MAINTENANCE INFORMATION

Mi98-38

DATE : September 1998	SECTION : 13
SUBJECT : Brake Air Chamber Cap Removal

Figure 1: Location of rubber caps on brake air chambers.

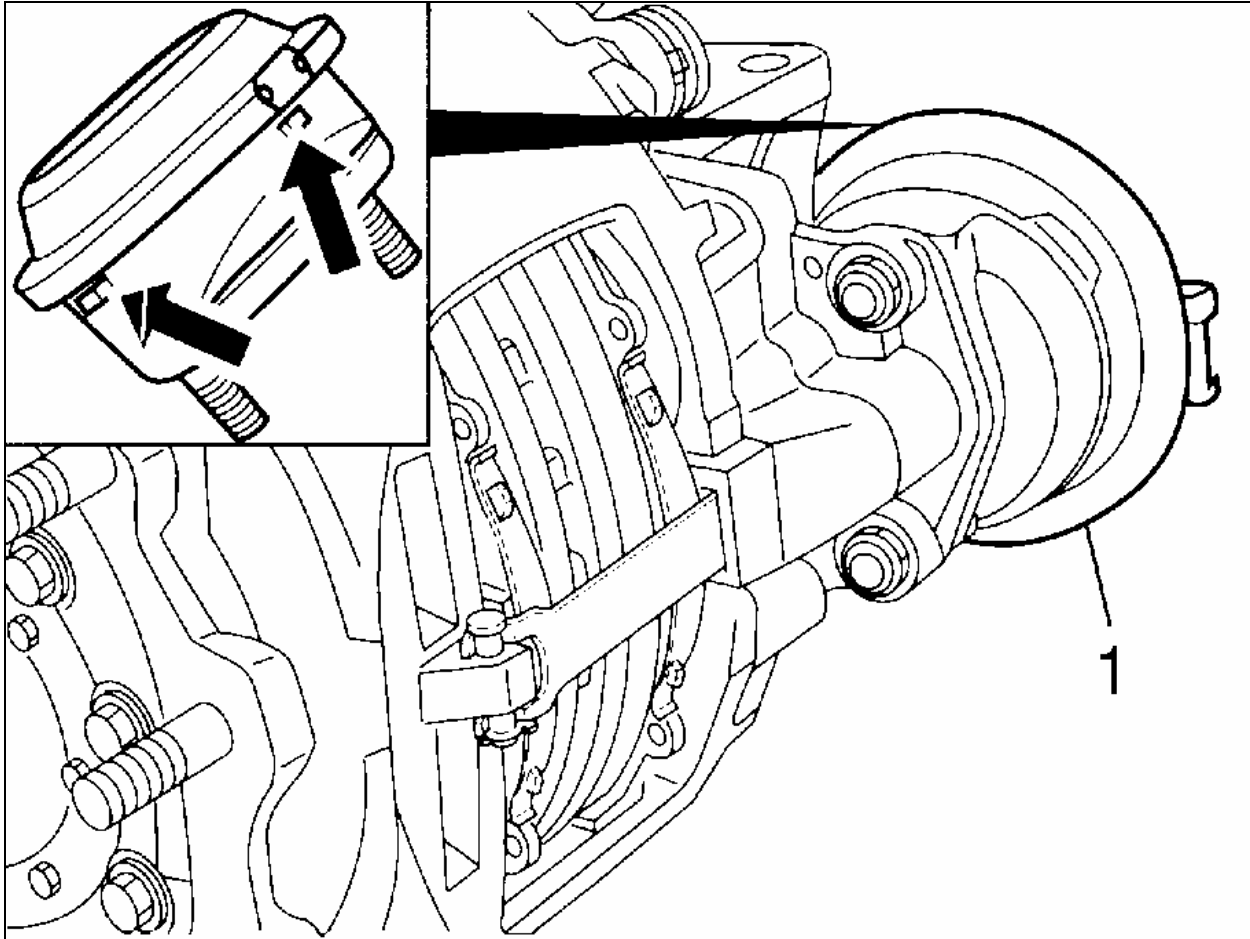
On the drive axle air brake chamber, a rubber cap needs to be removed in order to ensure the secondary chamber drainage.

1. Lift vehicle using proper jacking points (refer to your vehicle's Maintenance Manual for further details);
2. Locate each drive axle brake air chamber (see figure 1);

3. With a screwdriver, remove the lowest rubber cap located on the air brake chamber (see enlarged portion in figure 1). Proceed on both sides of the vehicle, but only on the drive axle;
4. Lower the vehicle.
